The Corporation of the District of Saanich

Report

To: Mayor and Council
From: Sharon Hvozdzanski, Director of Planning
Date: November 1, 2017
Subject: Development Permit and Rezoning Application
File: DPR00688; REZ00591 • 1586, 1588, 1592 North Dairy Road and
3200 Wordsworth Street

Figure 2: Site Plan

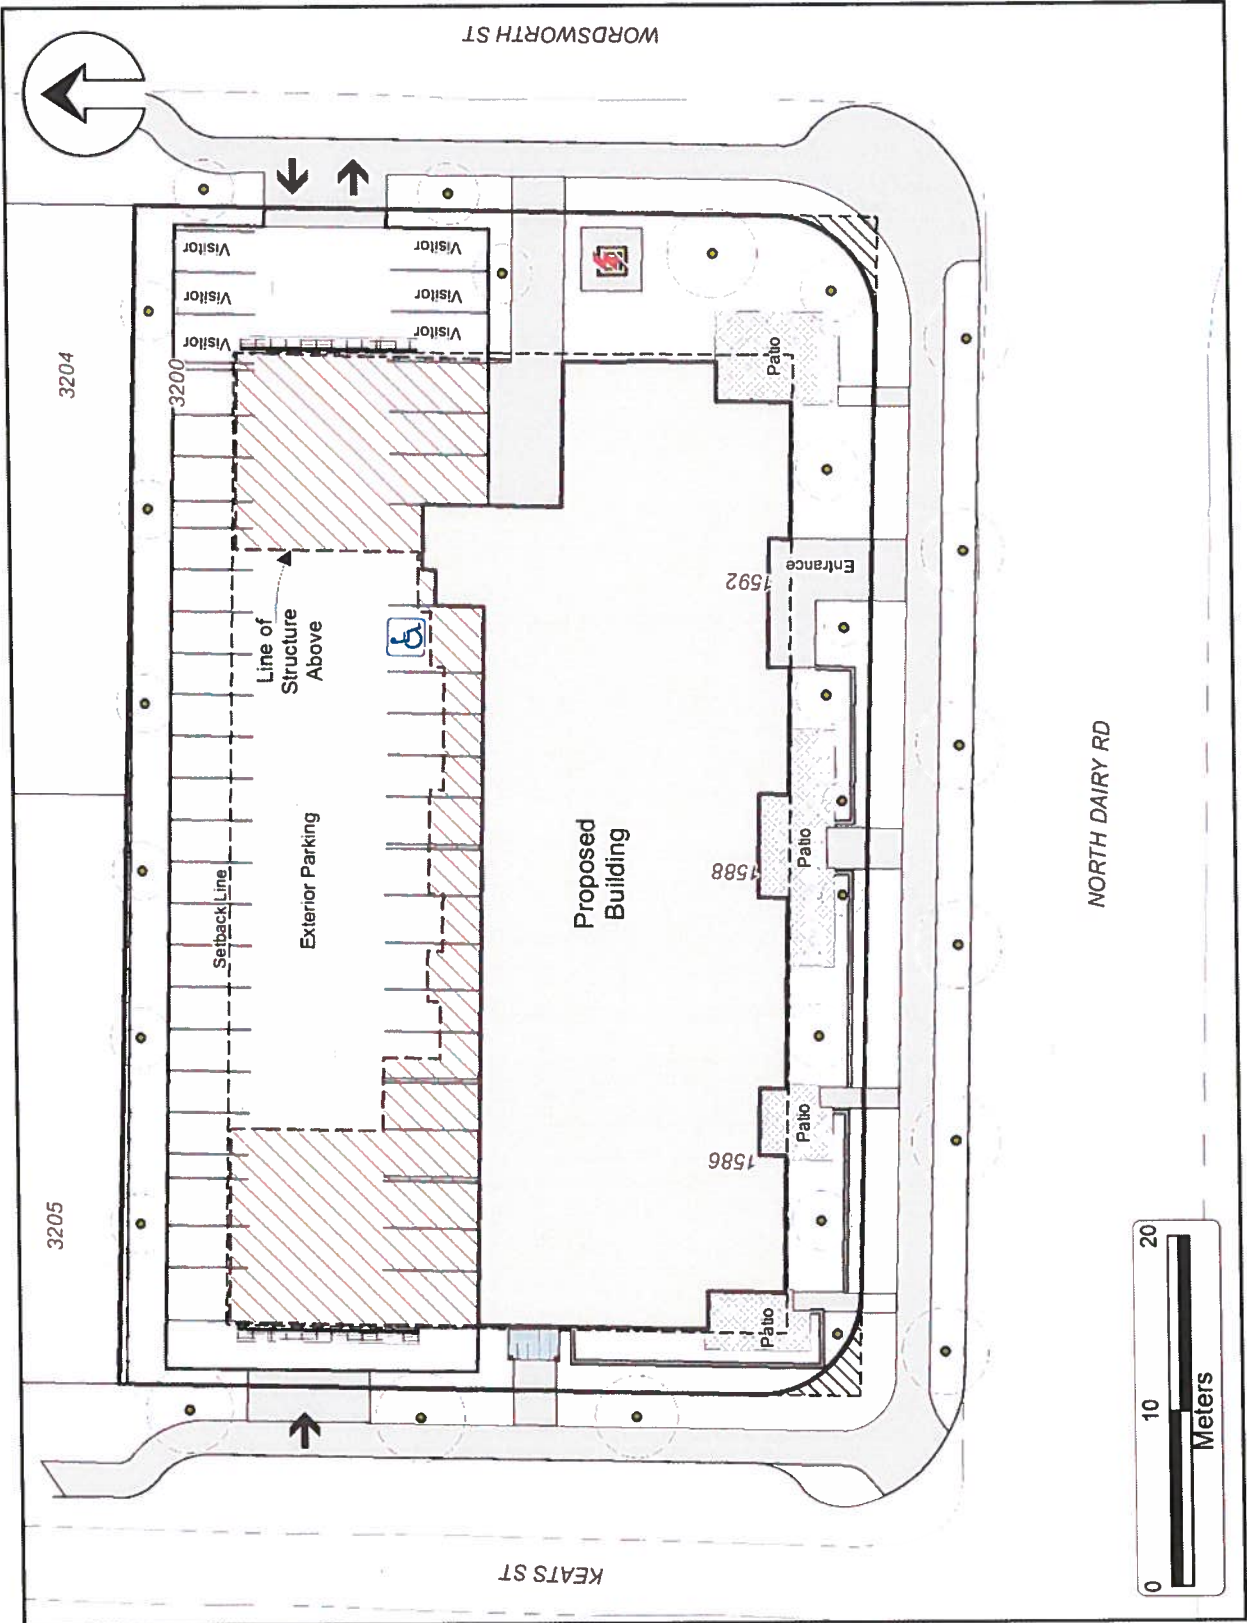
Surface parking would be located in the rear yard, behind and partially underneath the building. Vehicle access and egress would be through underbuilding openings that would include overhead arbours and security gates. Adjacent pedestrian entrances would have a compatible design with an overhead canopy and steel gate entry.

A total of 47 parking spaces (0.83 spaces/unit) are proposed, 6 being designated as visitor spaces. One of the visitor parking spaces would be dedicated as short-term parking only, which would provide a passenger loading and unloading area. One electric vehicle charging space in a visitor parking space is also proposed, which is reflected on the site plan. Electrical outlets would also be provided in the bike storage room to allow for recharging of e-bikes. Requested parking variances are discussed in the Variance section of this report.

The amount of lot surface used for parking and drive aisle is considerable at 42% of the lot. The parking configuration results in eight spaces being located fully underneath the second floor of the building and ten being approximately half underneath the building. The impacts of the amount of surface parking would be mitigated by screening and constructing with permeable pavers.

Two parking spaces on Keats Street frontage would be sited outside of the vehicle access gate, accessed from the main drive aisle. On the Wordsworth Street frontage the six visitor spaces would be located outside of the vehicle access gate, accessible from the main drive aisle, the outermost two would be 1 m from the lot line. All proposed parking spaces on the site would be configured as 90-degree parking accessed from one common drive aisle. A setback regulation for parking spaces to an exterior lot line relates to creating pedestrian oriented streetscapes and reducing impacts of siting large parking areas close to the street. The proposed parking spaces beside the property line would have adjacent landscape areas 1 m wide, which would be contiguous with the adjacent 2 m landscape area on municipal land. Given the location of these parking spaces they would not be expected to have the highest demand, as secured parking closer to the entrance would be preferred.

Figure 7: Cross Section – Through Side Extensions of Building (Provided by Low Hammond Rowe Architects)

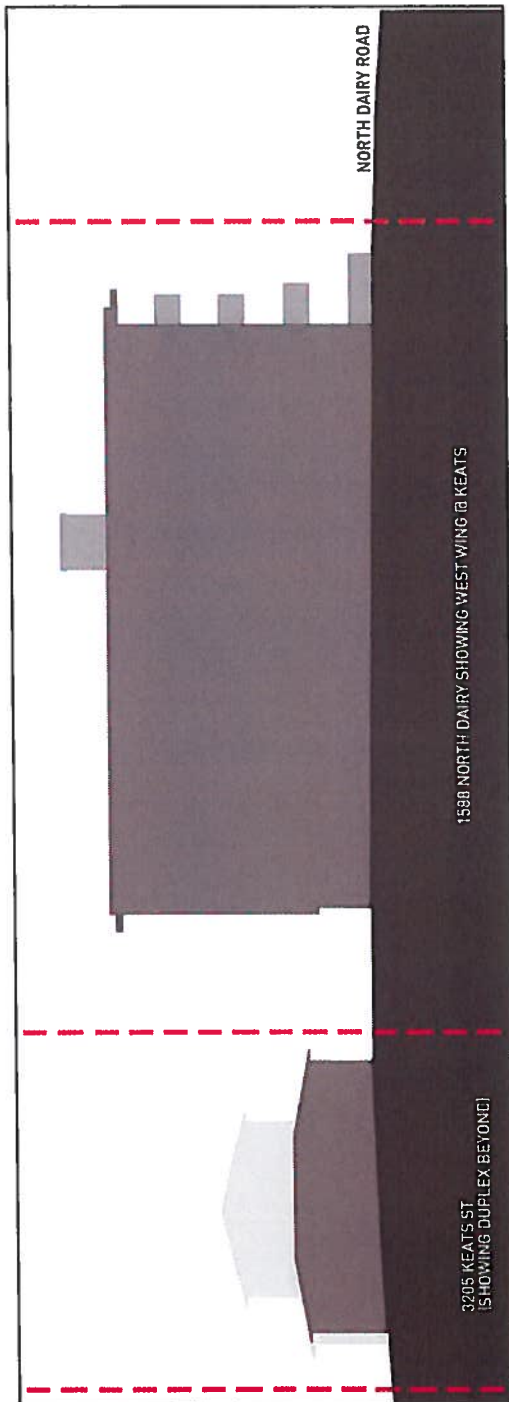
With respect to massing concerns, the proposed building would site a four storey building adjacent to relatively modest sized single family dwellings, with a relatively small rear yard setback (see Figures 7 & 8). Staff believe that a more suitable transition in height to the neighbouring properties should be considered, such as stepping building to three storeys on the north portion of the building closest to the single family dwellings. The massing concern is exacerbated by a rear yard that would be utilized for parking. If the rear yard provided useable outdoor areas it could also provide a better relationship with the neighbourhood. Staff acknowledge that the long term vision of the SVAP would allow townhouses up to three storeys to the rear of the proposed apartment, however redevelopment of the adjacent properties may not occur for many years.

The reduced setback to the rear lot line raises concern because it would apply to all of the upper storeys (levels 2 to 4). Staff acknowledge the building design has attempted to minimize impacts from the proposed setback, however stepping back of the 4th level would further mitigate impacts to neighbours and provide a smoother transition to adjacent single family

Figure 9: Shadow Study (Provided by Low Hammond Rowe Architects)

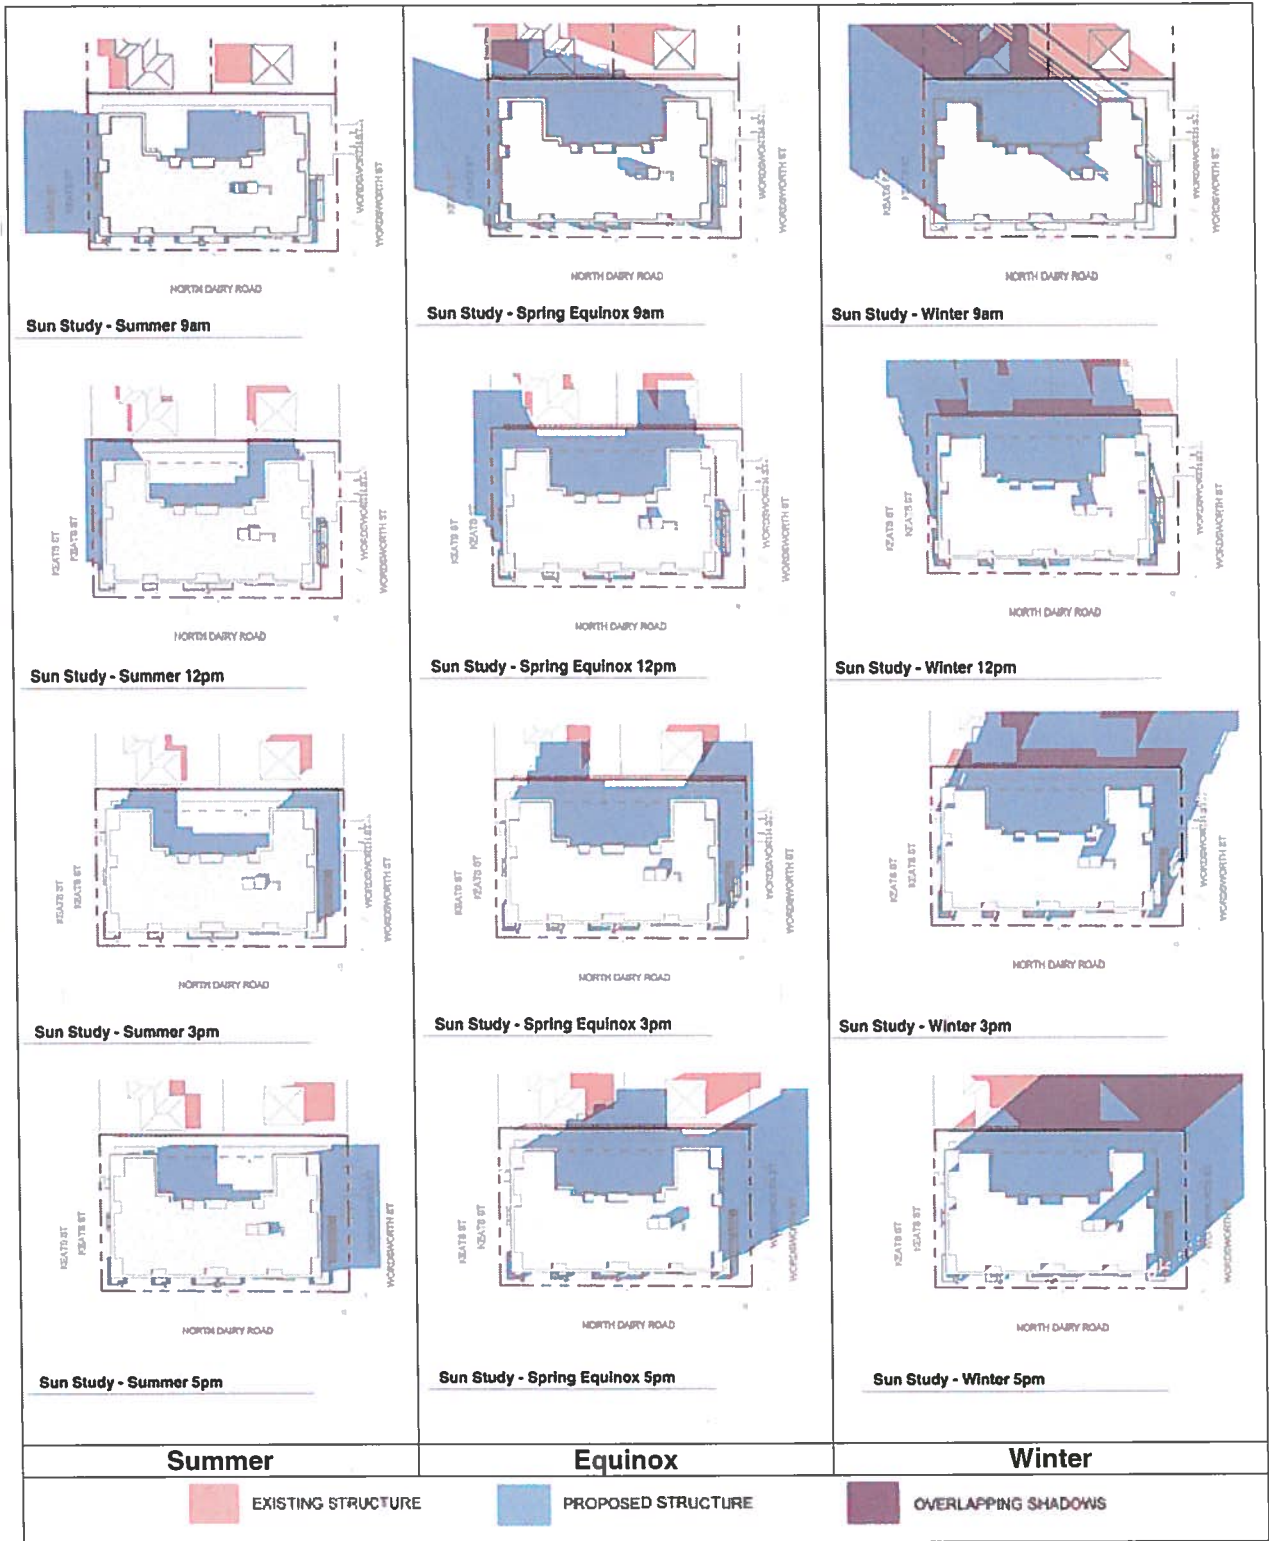
The applicant provided shadow studies to consider impacts to adjacent homes (see Figure 9). The shadow study also captured impacts from existing structures and where they would overlap with shadow cast by the proposed apartment. As expected, shadow impacts would be from early morning to early afternoon in the winter, and during spring and fall the impacts would be in early morning and late afternoon. As part of their neighbourhood consultation, the applicant completed shadow studies to reflect the existing trees (evergreen) and the scenario if single-family homes were constructed on the lots.
